SP2006-019
Hampton Inn
1529 Laguna Drive

AGENDA ITEM: SP2006-019; Hampton Inn

Project Number SP2006-019 Project Name Hampton Inn Type SITE PLAN Subtype Status Staff Review	Applied 6/19/2006 KW Approved Closed Expired Status
--	--

RE: SP2006-019, Hampton Inn
Project Type: SITE PLAN

SITE PLAN
SCALE: 1" = 30'-0"
Scale 1" = 30'

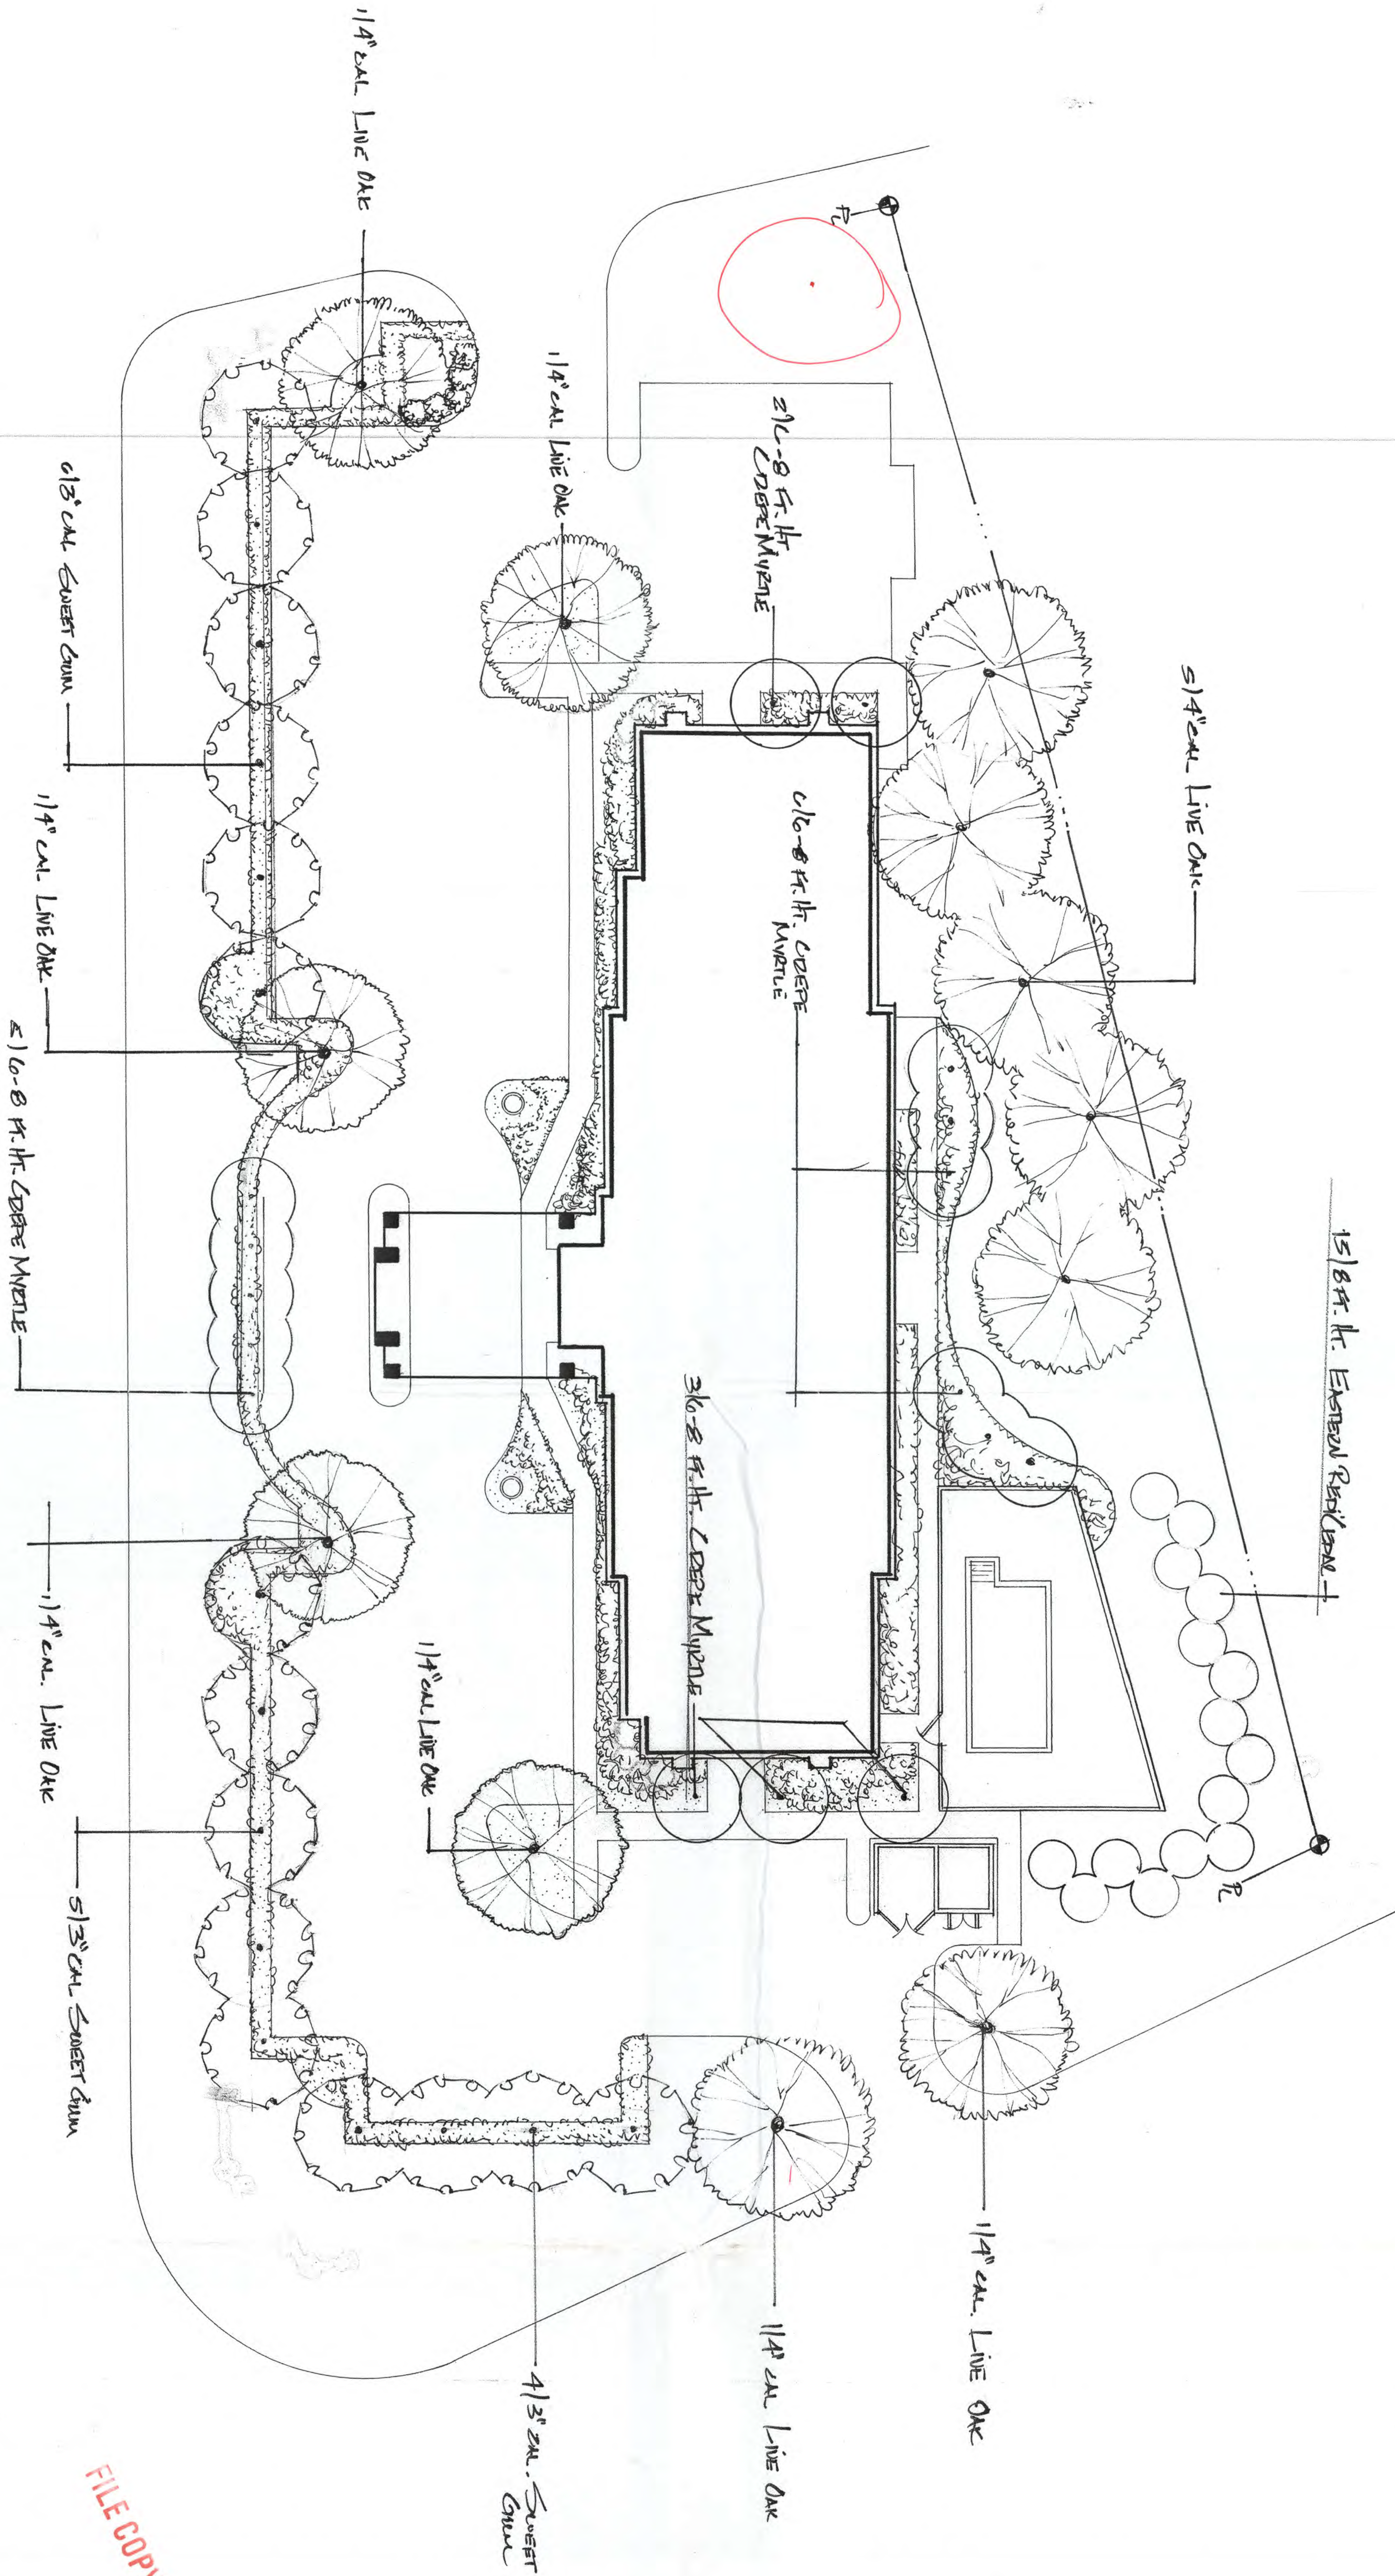
- ENGINEERING REQ.
- FIRE DEPT. REQ.
- TURN DUMPSTER AWAY FROM STREET.
- EIFS NOT ALLOWED FOR THAN 10070.

ELEV-1

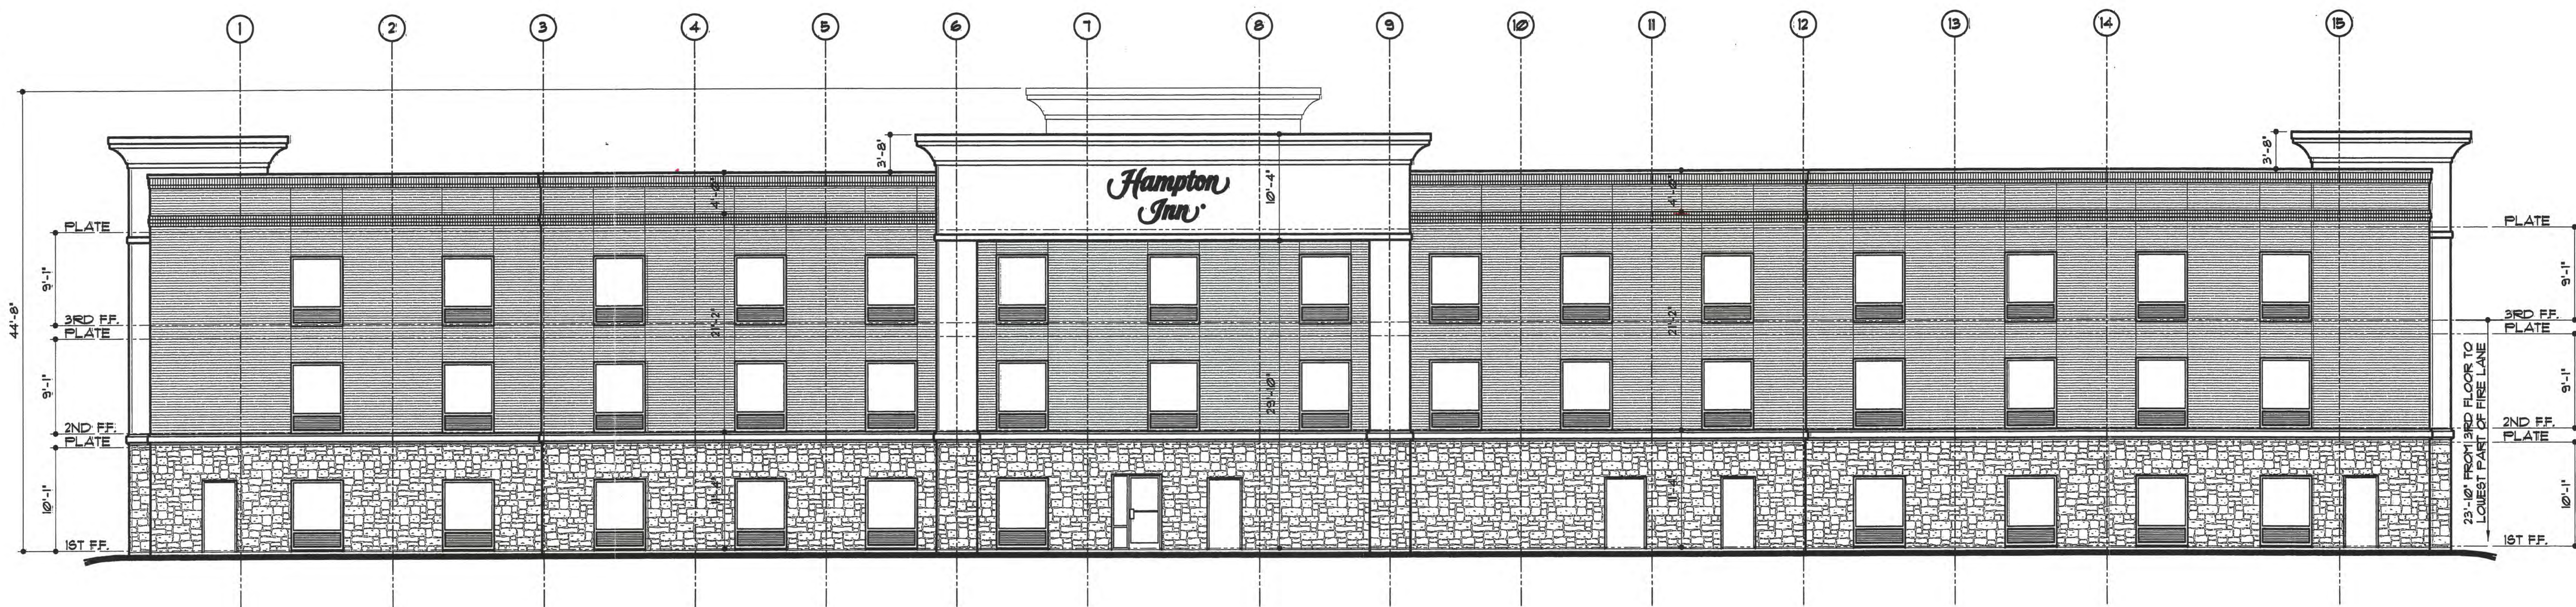
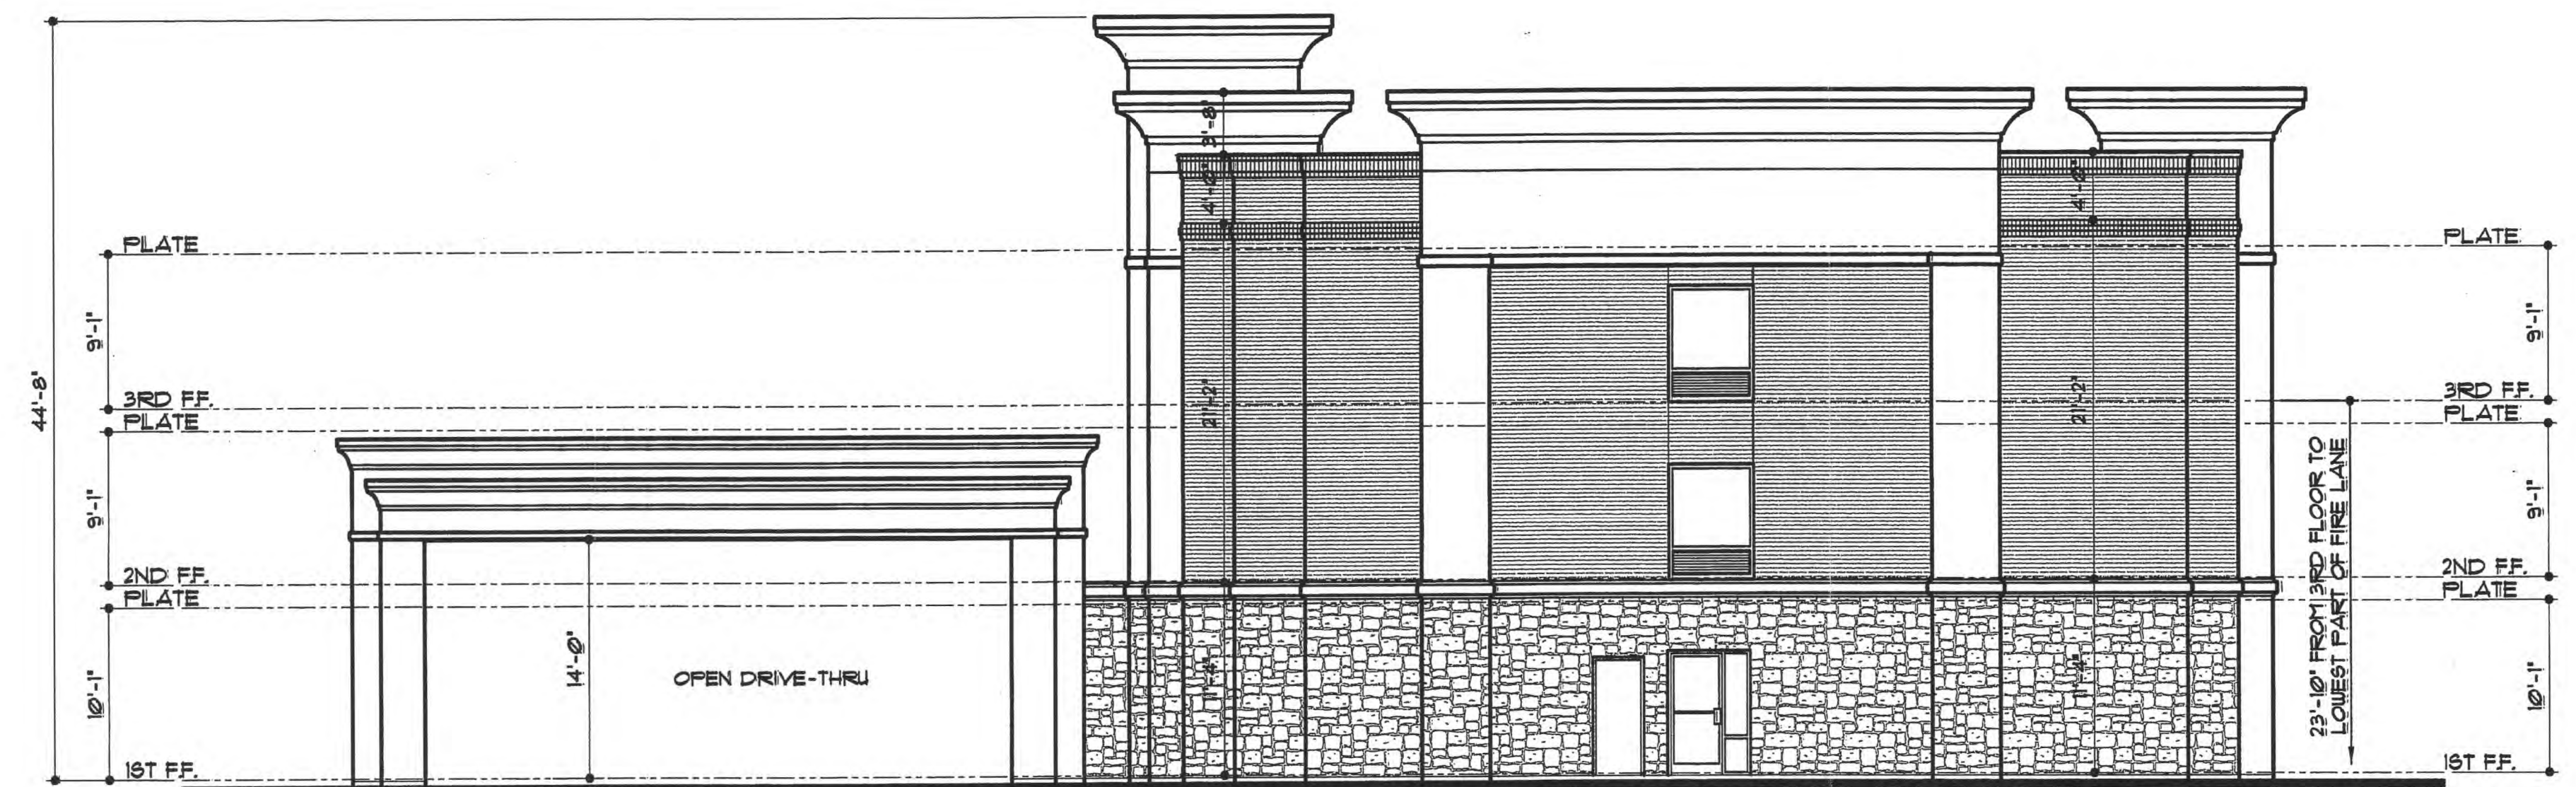
NATURAL

MAX 10% allowed in I-30

Static Material
Not allowed w/in 4'
of Finish Floor

MAX 10%

MAX 10%
